SUBJECT: Forwards responses to NRC comments re proposed changes to  
 FSAR submitted in util 860819 ltr. Marked up FSAR pages encl.

September 19, 1986  
(NMP2L 0881)

Re: Nine Mile Point Unit 2  
Docket No. 50-410

TABLE 6.2-59D

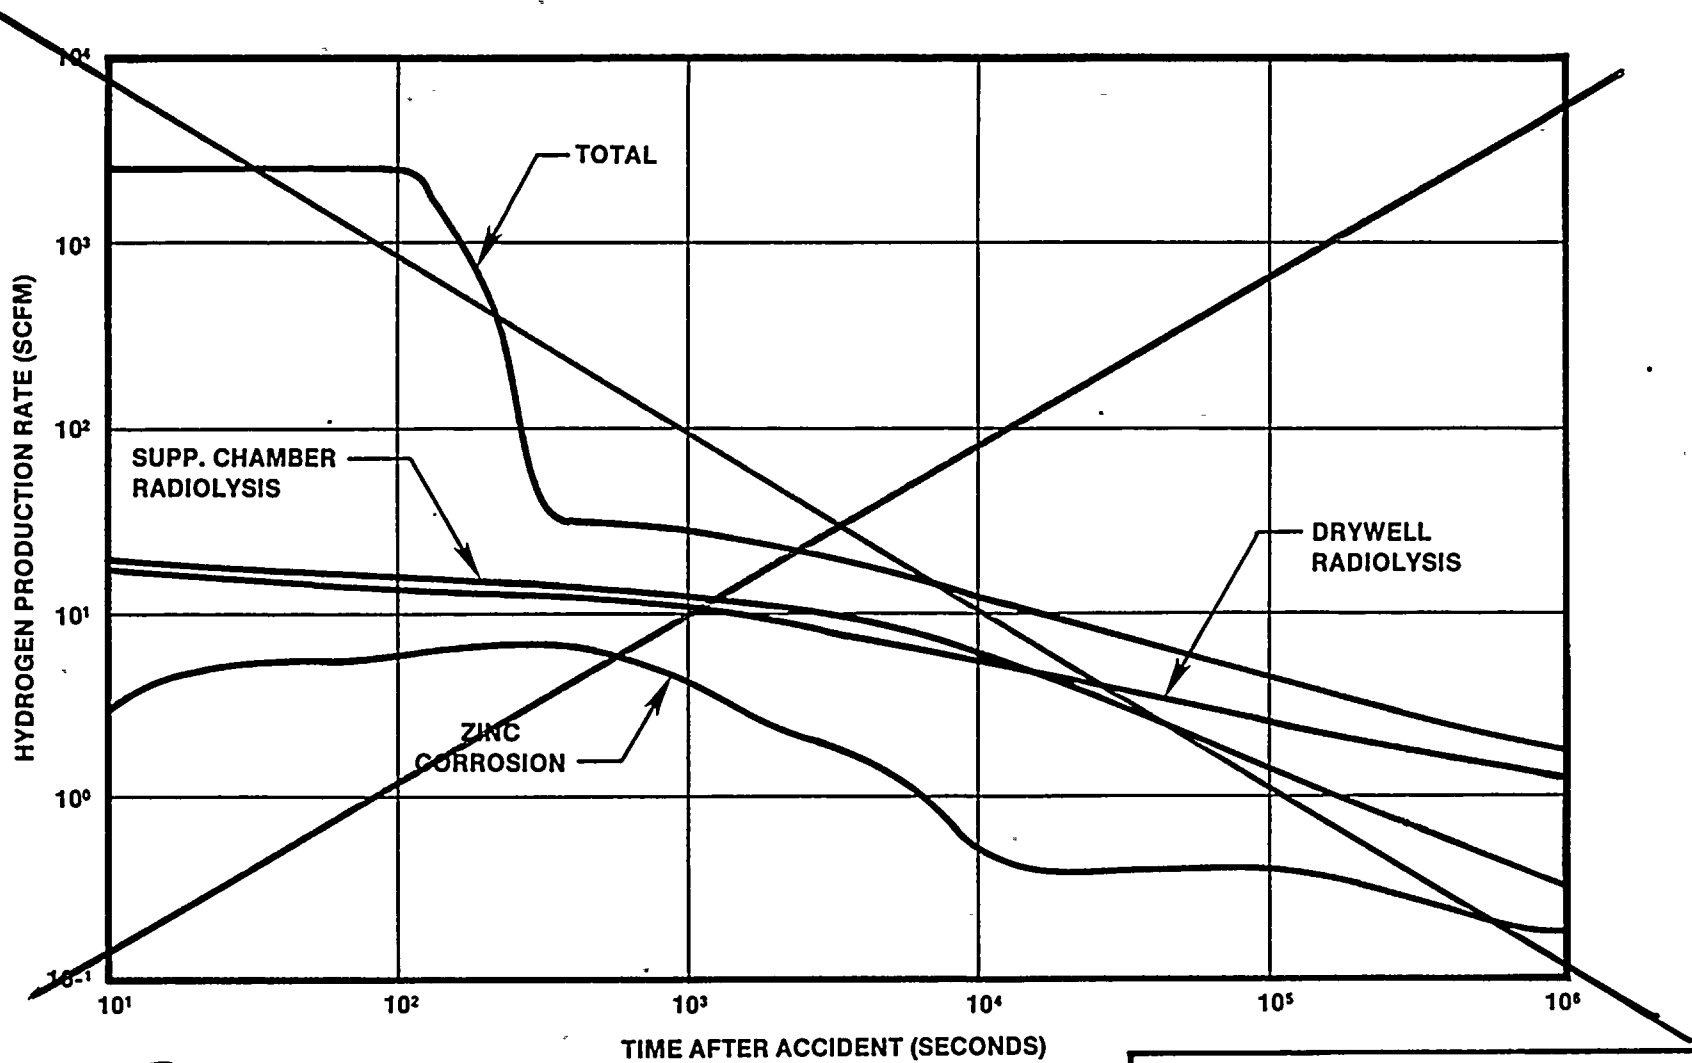
2. FSAR Table 6.2-59D

Comment: Zinc primer number is not accurate.

Response: A footnote which clarifies the consideration of the zinc primer for hydrogen generation was inadvertently left out. Although the consideration of additional hydrogen generation from zinc primer was considered in the calculations, this table and the associated hydrogen generation curves were not updated. In order to resolve your concern, this table, the hydrogen generation curves in figures 6.2-72D, E, H and I, and text pages 6.2-76a and 6.2-81 are updated and are provided in this enclosure. The attached changes will be included in a subsequent Final Safety Analysis Report update. There is no Technical Specification change necessary.

<u>Material Type</u>	<u>Surface Area (ft<sup>2</sup>)</u>	<u>Weight (lbm)</u>
Aluminum	650	<del>41,500</del> 40,300
Galvanized steel	<del>58,540</del> 57,600*	<del>6,968</del> 5,370*
Zinc primer	<del>2,400</del> 39,400*	<del>230</del> 3,780*

\* The hydrogen generation / control analysis considers 15 percent larger surface area and weight as a conservative allowance for the uncertainty of these inventories.
